**RECALL
BULLETIN:
200728REV**

AFFECTED:
Pace Arrow
manufactured
January 11, 2019 -
February 28, 2020

SUBJECT:
Inspection /
Correction of
Battery Hold-
Down Mounting
Hardware

ISSUE DATE:
September 2020

Figure 2 - Correct Battery Hold-Down Installation With Plastic Spacer Brackets Shown

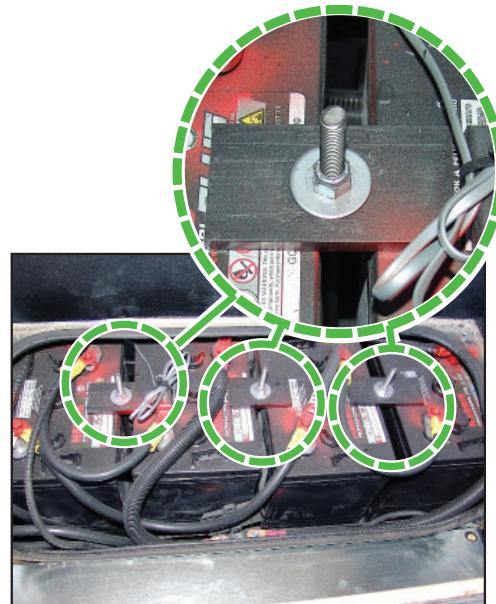
5. Inspect the auxiliary batteries, wiring and mounting hardware for any signs of arcing or damage. Also inspect the hardware securing the battery hold-down brackets:
 - If the battery hold-down mounting hardware consists of L-shaped bolts, rectangular **plastic** spacer brackets, washers, and locking nuts (as shown in Figure 2), the installation is correct and no further action is required.
 - If **metal** battery hold-down mounting brackets are installed and/or carriage bolts or non-locking washers were used as fasteners to secure the battery hold-down hardware, the installation is defective and these components will need to be removed and replaced by a kit containing new plastic spacers, L-shaped bolts, flat washers, and locking nuts.

Figure 3

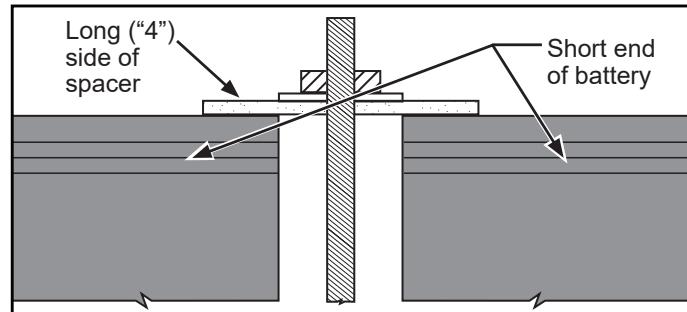
11. Feed the straight end of the L-shaped bolt through the center hole in one of the new plastic spacers from the repair kit. Be sure to orient the longer (4") side of the new plastic spacer bracket to span the gap between the batteries. Install the flat washer and locking nut. Initially hand-thread the bolt into the nut to prevent cross-threading.

Refer to the stacking order in Figure 3 and the photo in Figure 4 showing the orientation of the spacer(s).

Kit Contents:

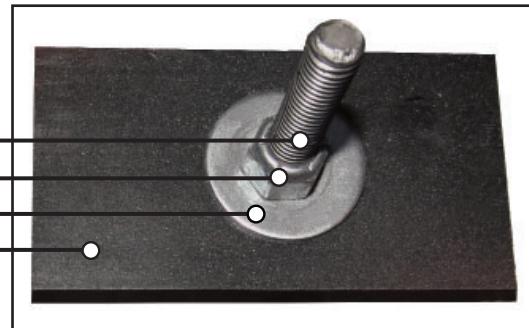
8. Locate the repair kit containing three (3) each: plastic spacer brackets, L-shaped bolts, flat washers and locking nuts. Refer to the photo of the repair kit parts adjacent to the Parts list on Page 5.

- Bolt-3/8-16X12 Battery Hold-Down / L-Hook (qty. 3)
 Nut-3/8-16 HH Locking Pltd (qty. 3)
 Washer-3/8 USS Flat Pltd (qty. 3)
 Battery Hold-Down Spacer 2" x 4" x 1/4" (qty. 3)
